ARKANSAS NUCLEAR ONE, UNIT 1

AMENDMENT TO FACILITY OPERATING LICENSE

Amendment No. 105
License No. DPR-51

SAFETY EVALUATION BY THE OFFICE OF NUCLEAR REACTOR REGULATION
SUPPORTING AMENDMENT NO.105 TO FACILITY OPERATING LICENSE NO. DPR-51
ARKANSAS POWER AND LIGHT COMPANY
ARKANSAS NUCLEAR ONE, UNIT NO. 1
DOCKET NO. 50-313

Boric Acid Addition Tank Volume and
Concentration Vs RCS Average
Temperature -- ANO-1, Cycle 8
Figure 3.2-1

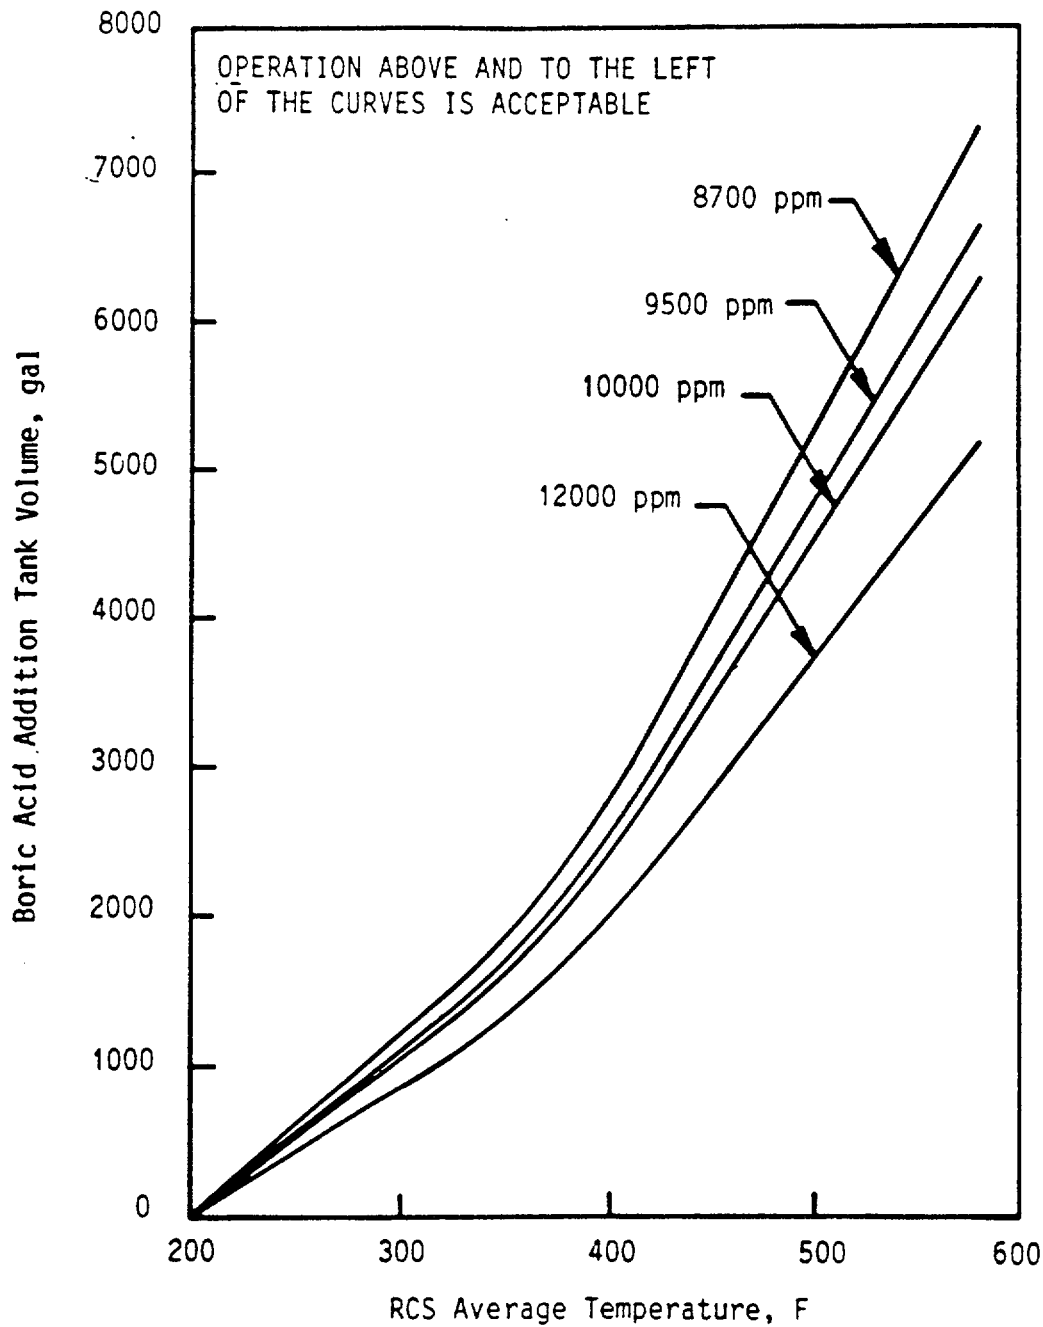
1. A new Figure 3.2-1 will be provided giving the boric acid addition tank volume and concentration as a function of reactor coolant system temperature to accommodate Cycle 8 shutdown margin requirements.

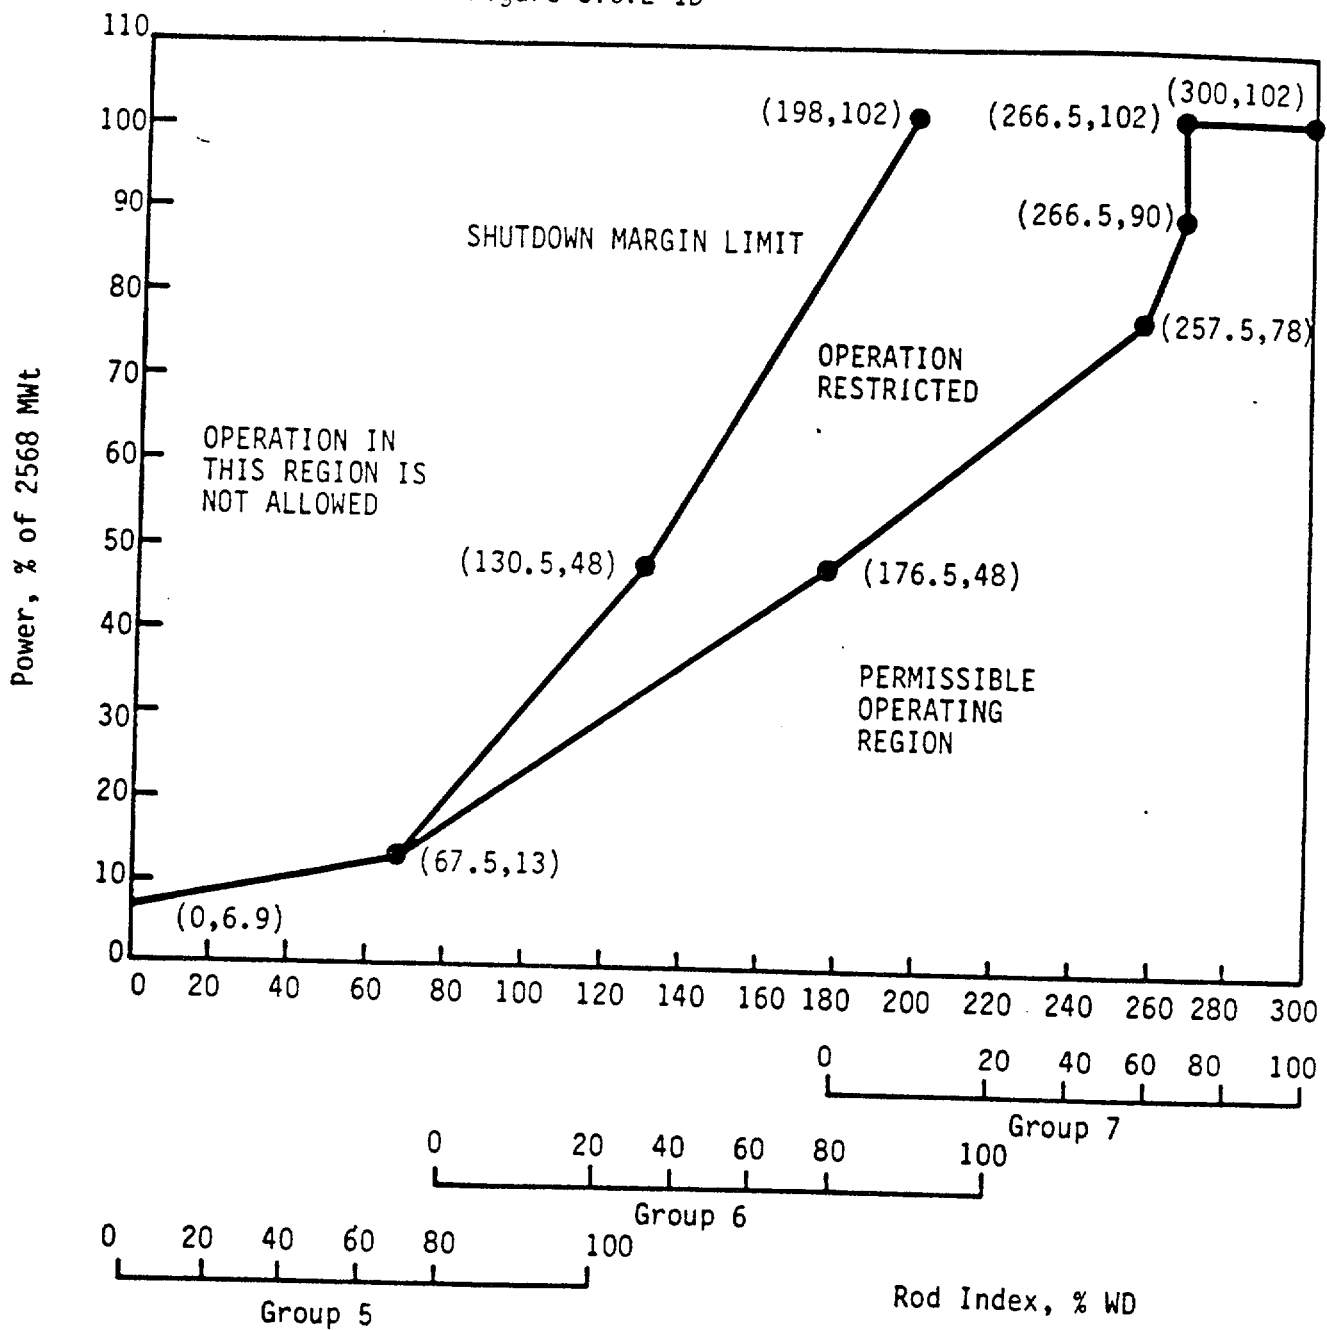
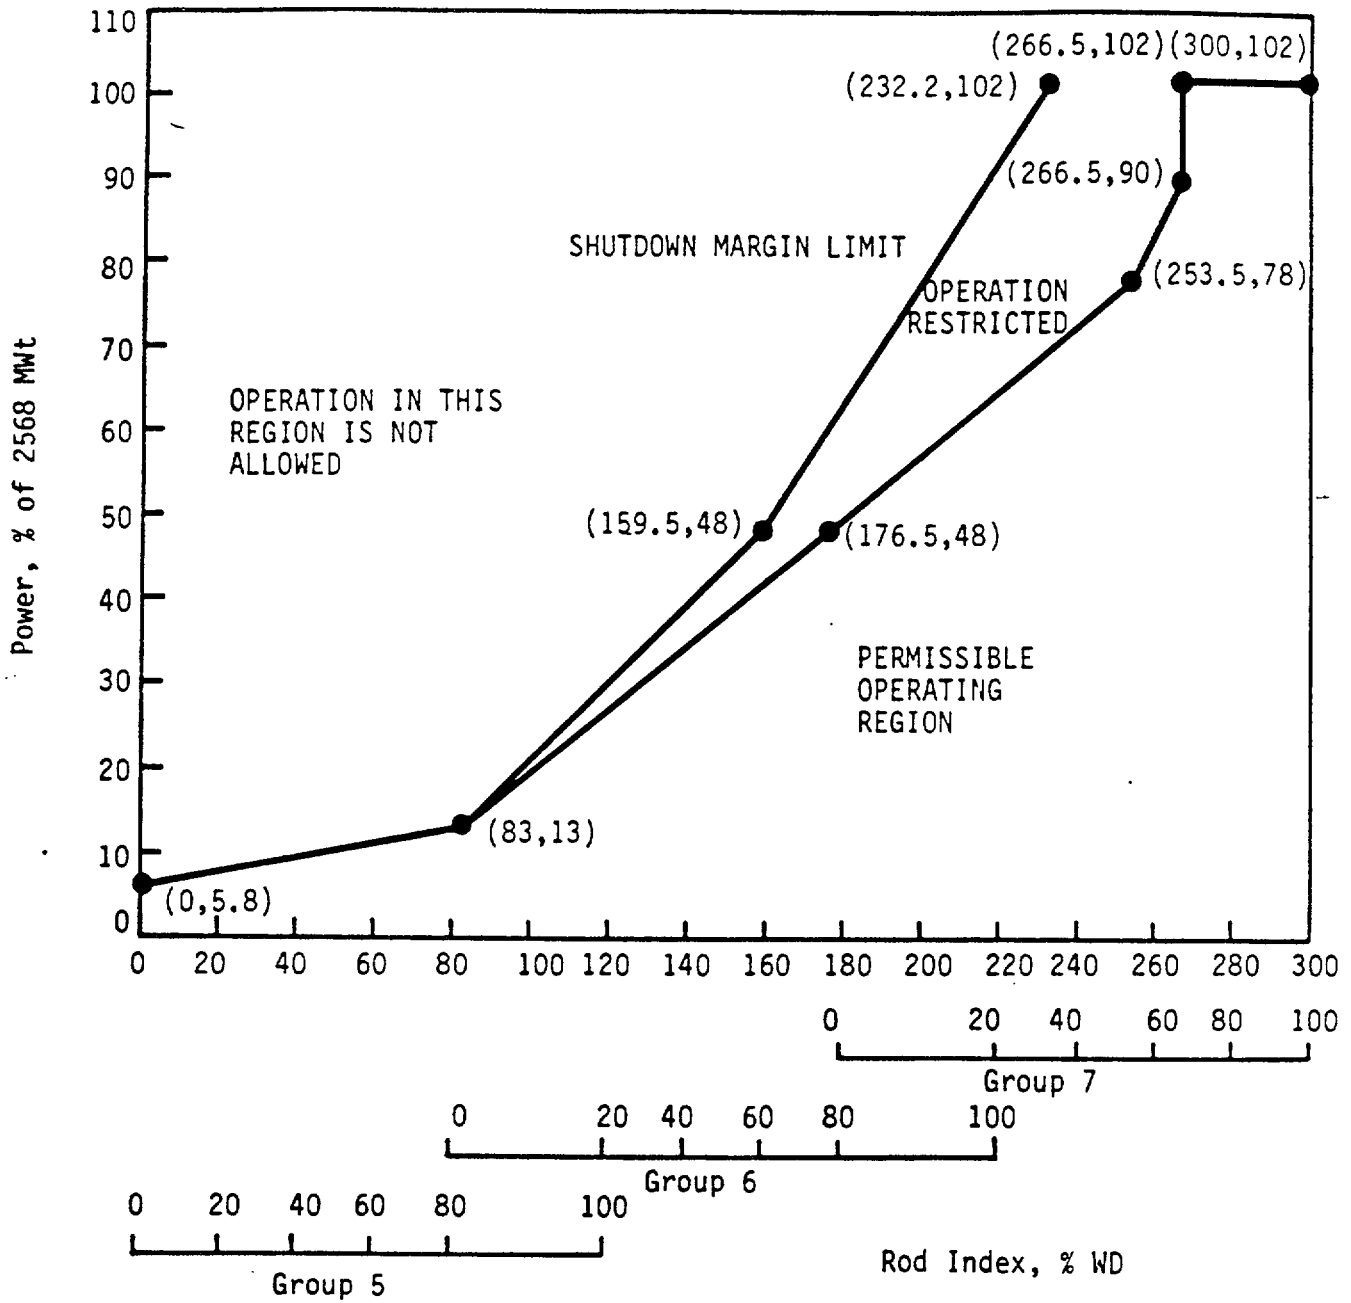
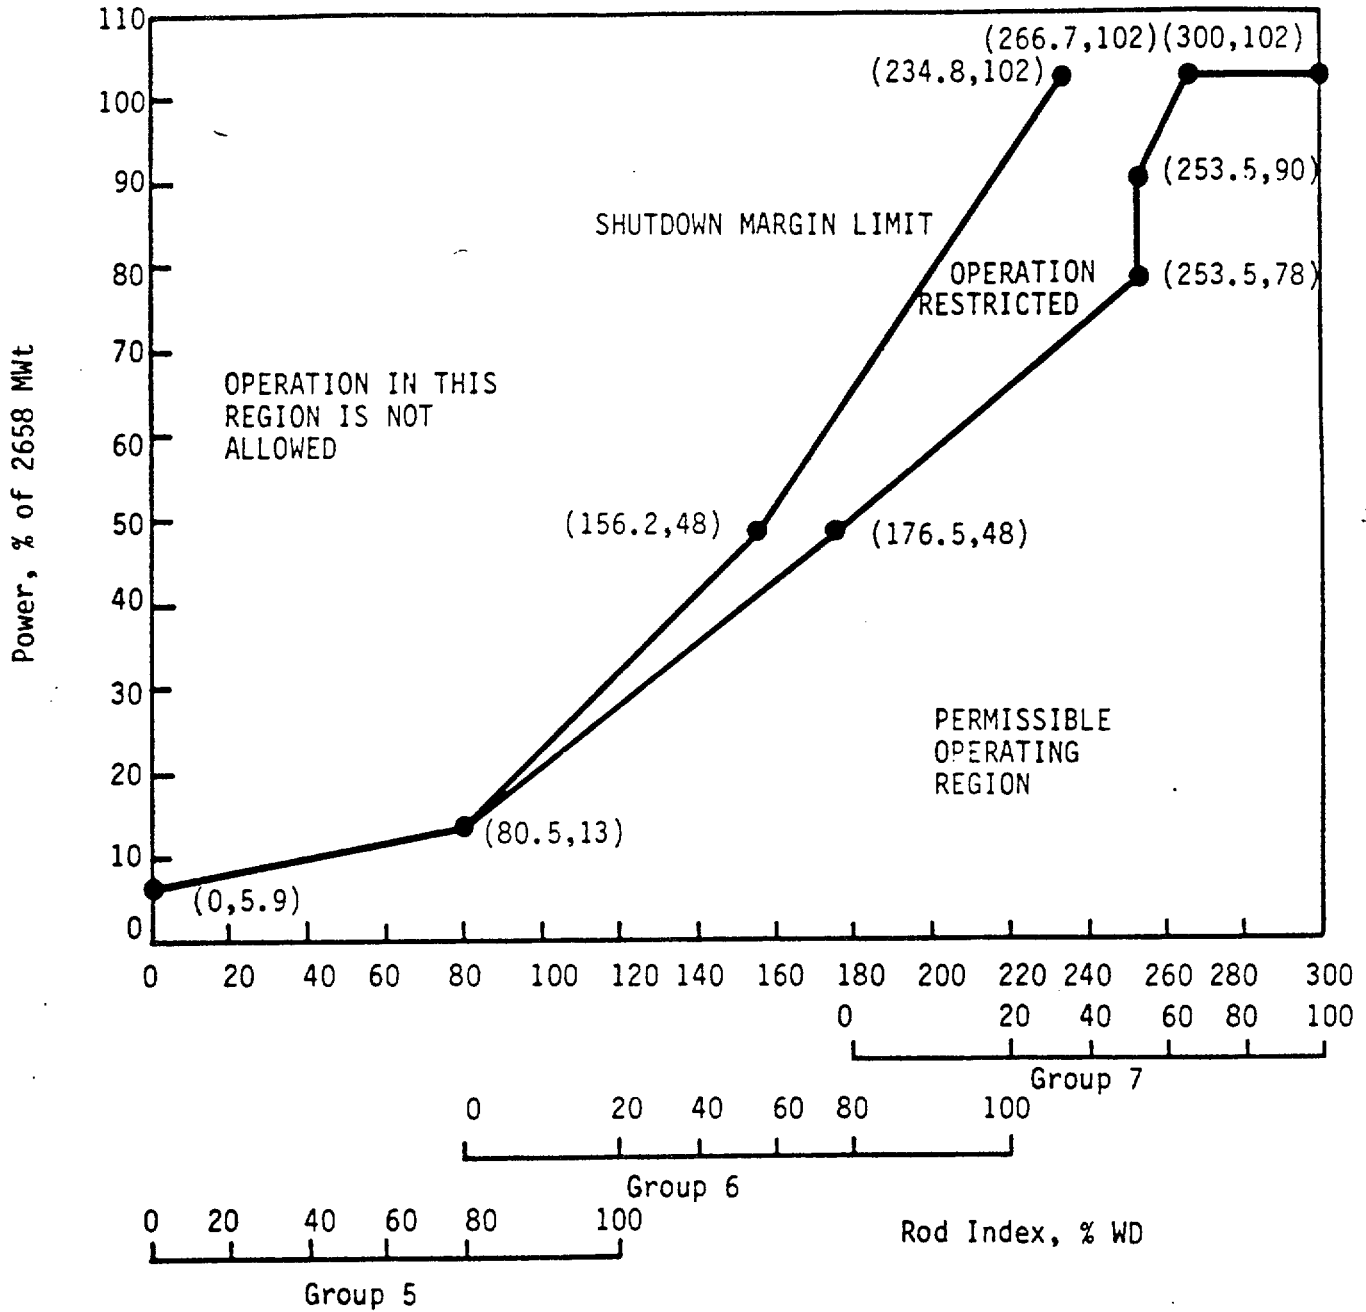
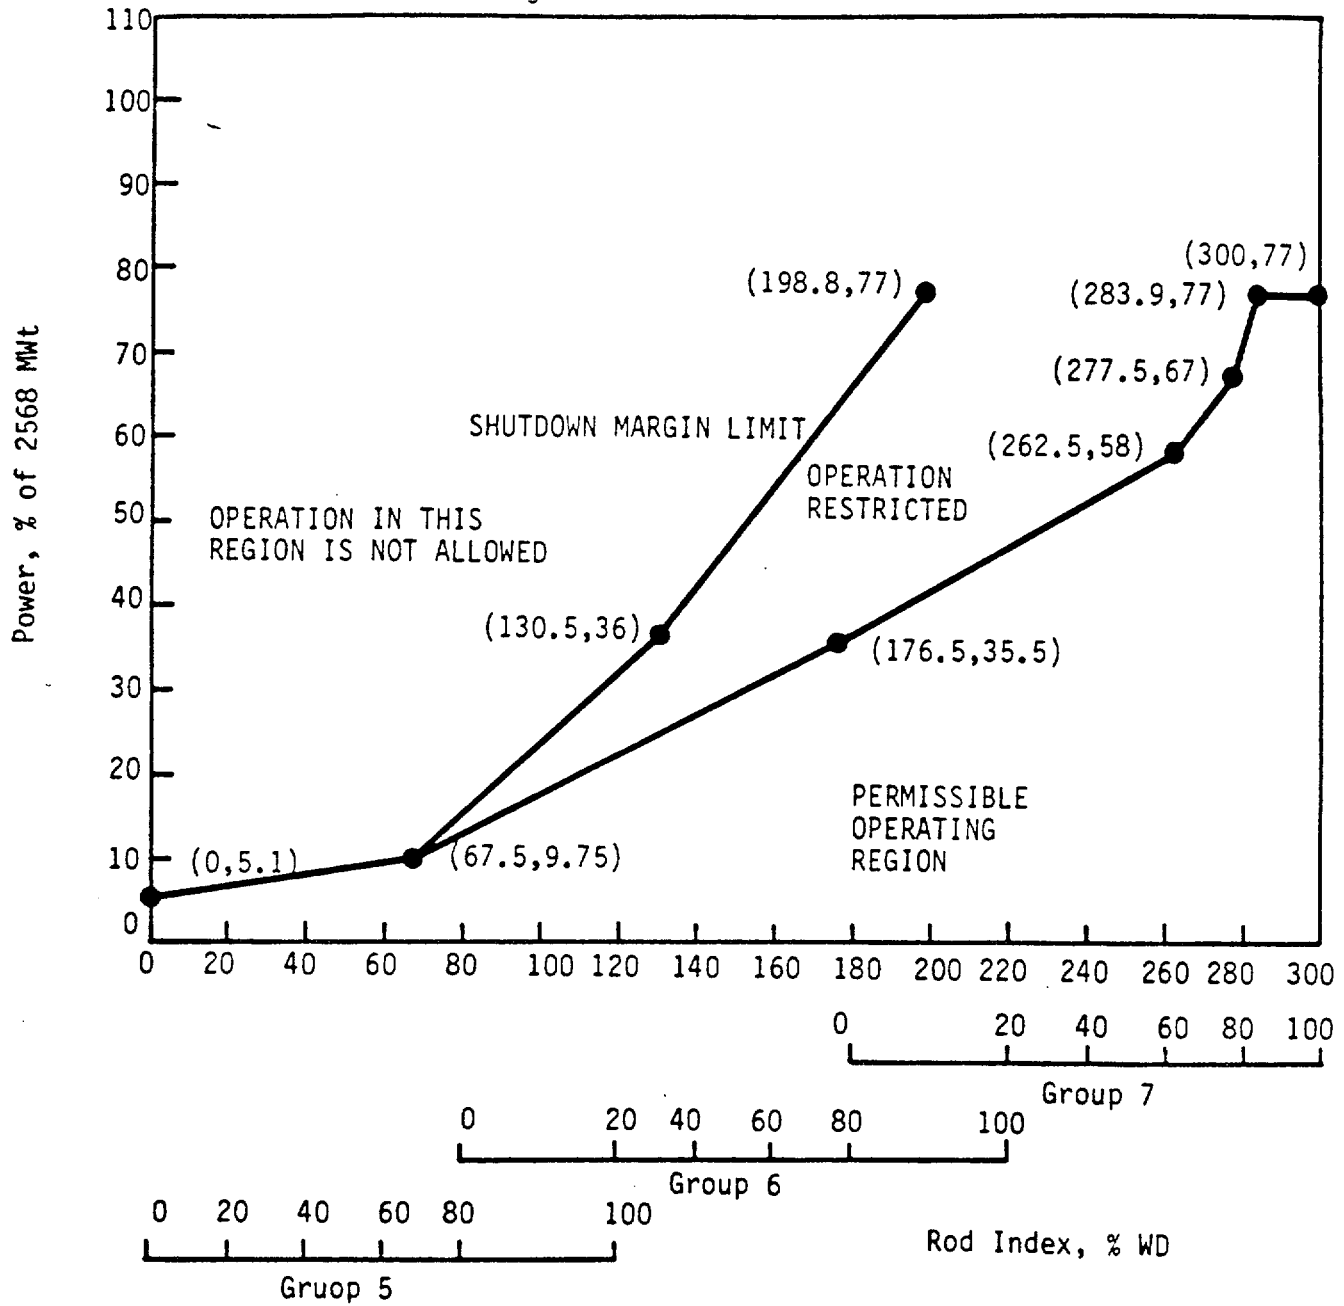
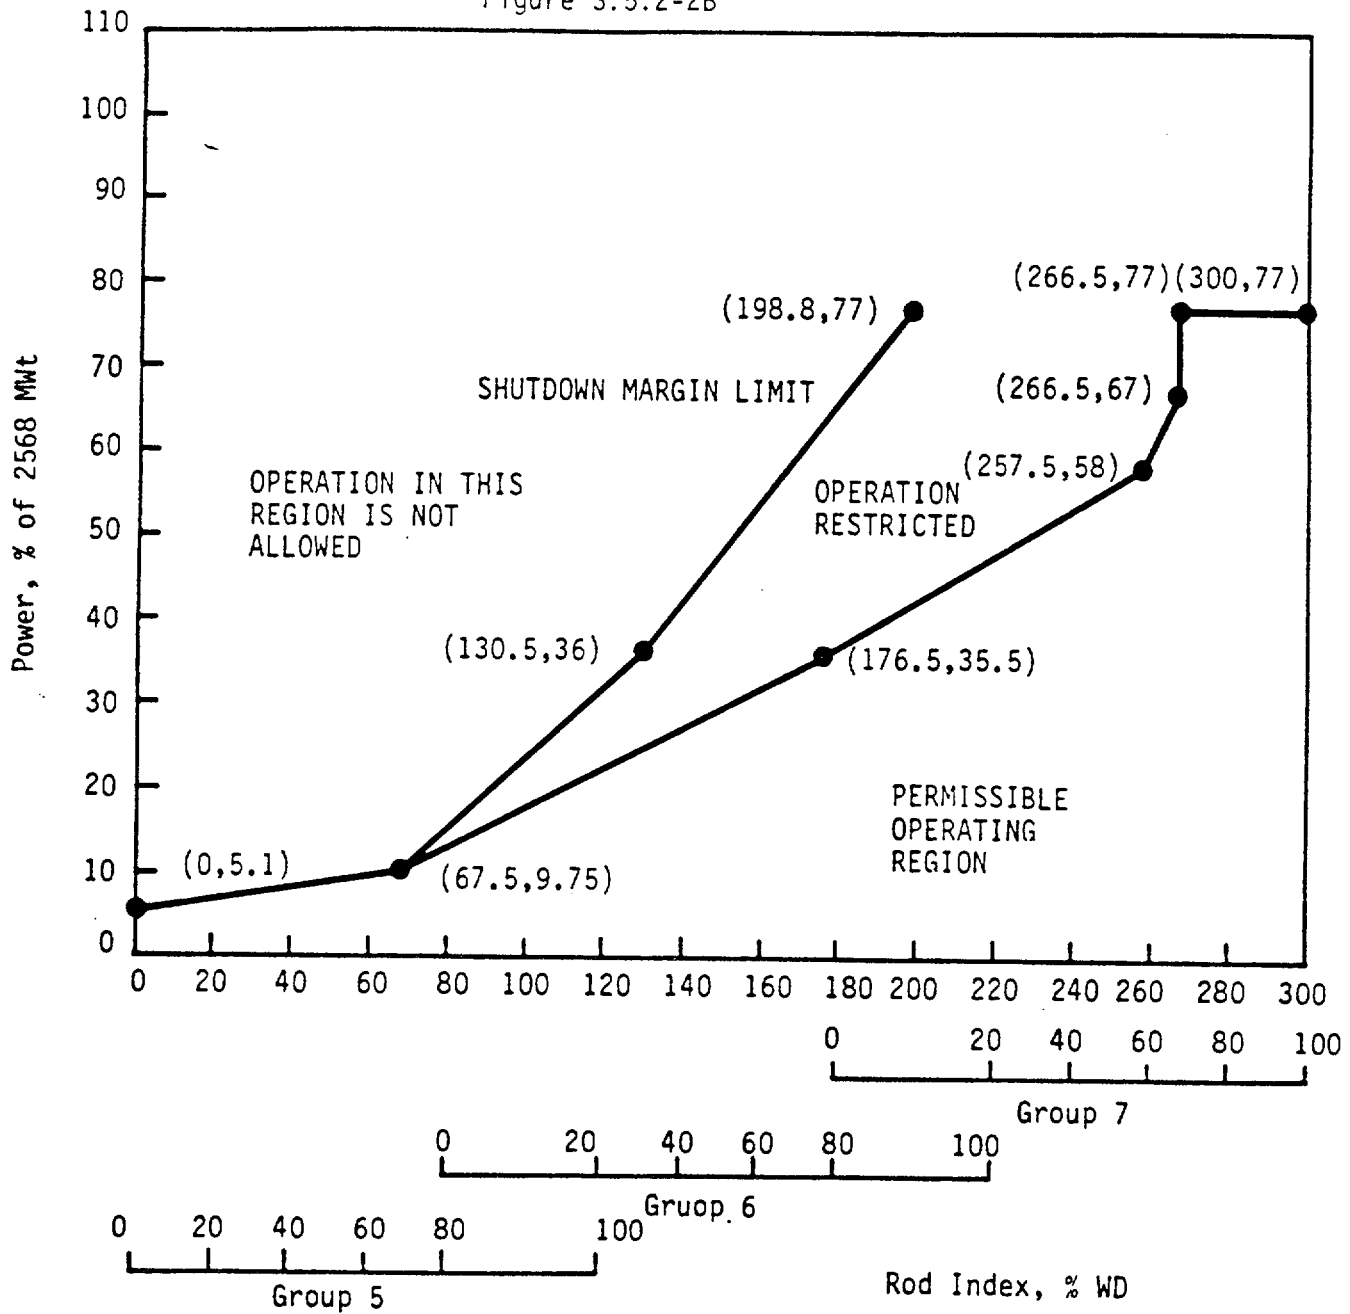
3. Except for physics tests or exercising control rods, (a) the control rod withdrawal limits are specified on Figures 3.5.2-1(A-D), 3.5.2-2(A-D), and 3.5.2-3(A-D) for 4, 3 and 2 pump operation respectively; and (b) the axial power shaping control rod withdrawal limits are specified on Figure 3.5.2-6(A-D). If any of these control rod position limits are exceeded, corrective measures shall be taken immediately to achieve an acceptable control rod position. Acceptable control rod positions shall be attained within 4 hours.

2. TS 3.5.2.4.1 Quadrant Tilt
The power level cutoff requirement has been deleted.
3. TS 3.5.2.5.3 Control Rod Positions
New control rod insertion limits are provided for 4, 3 and 2 pump operation, as well as a function of burnup interval. APSR limits are also provided as a function of burnup interval.
